Buildcert  
Access Design Assessment Report

Old Byron Bay Hospital Repurpose  
Cnr Wordsworth and Shirley Street  
Byron Bay NSW 2481

Project: Old Byron Bay Hospital Repurpose  
Document Type: Access Design Assessment Report  
Our Reference: P221\_011-1 (ACCESS) KG

**Figure 1 – Pedestrian Entries**

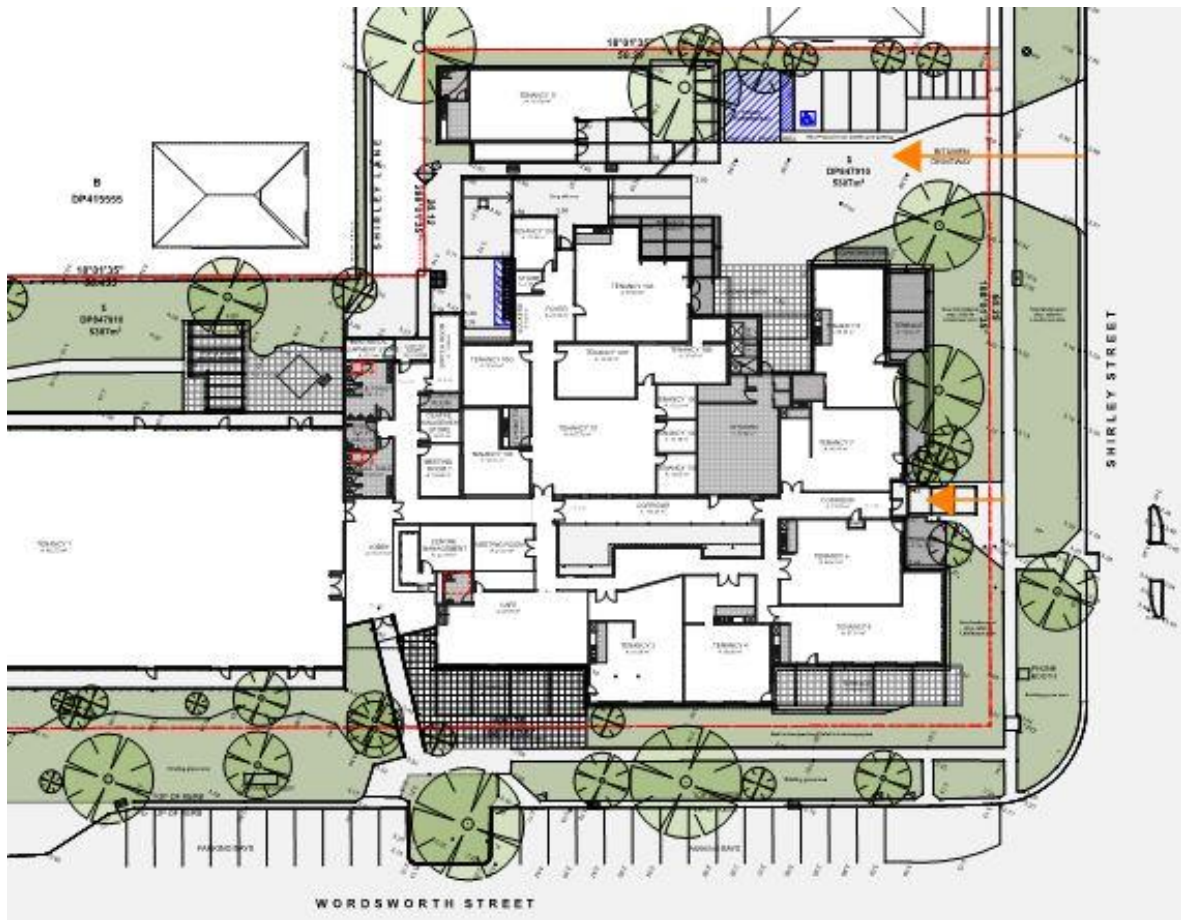
| DESCRIPTION                     | COMPLIANCE DEPARTURE  | RESOLUTION   |
|---------------------------------|---|--|
| Walkway                         | The walkway from Shirley Street is provided with ~1:24 gradient with no landings provided to the top and bottom and no suitable barrier to both sides of the walkway. | Provide landing to the top of the walkway, compliant with AS1428.1-2009.<br><br>Provide evidence that public domain area is not less than 1:40 grade. If that is not achieved a landing will have to be provided at the bottom of the walkway, compliant with AS1428.1-2009. |
| General - Tenancy 8             | Tenancy 8 is not provided with access from the site boundary.   | Provide access to Tenancy 8, compliant with AS1428.1-2009.   |
| Main building – Entry door      | Entry door reduced circulation space is provided on a walkway ~1:24 gradient.   | Provide required door circulation space on a 1:40 gradient, compliant with AS1428.1-2009.  |
| Tenancy 11 – Clear door opening | Entry door to Tenancy 11 is provided with reduced clear door opening.   | Provide minimum 850mm clear door opening, compliant with AS1428.1-2009.  |

Drawing  
Elevations

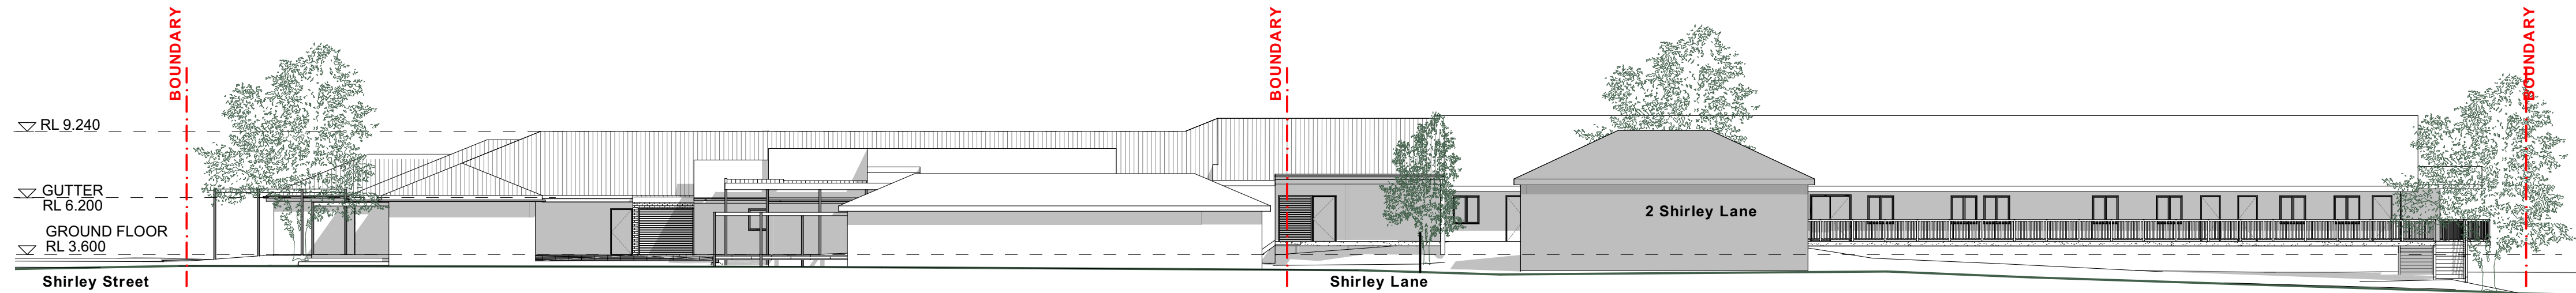
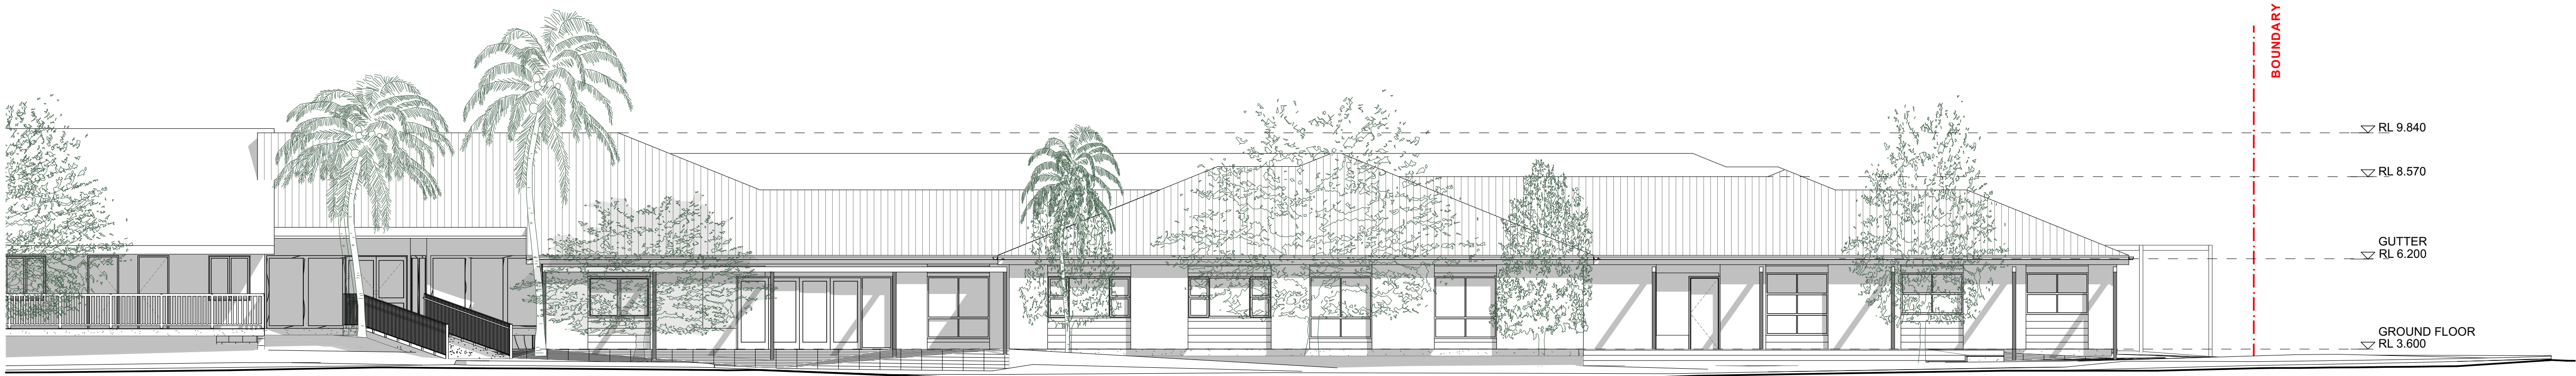
GENERAL - FULL GLASS DOORS AND FULL HEIGHT WINDOWS:  
Provide visual indicators to all full height windows and fully glazed doors on a continuous accessible paths of travel.
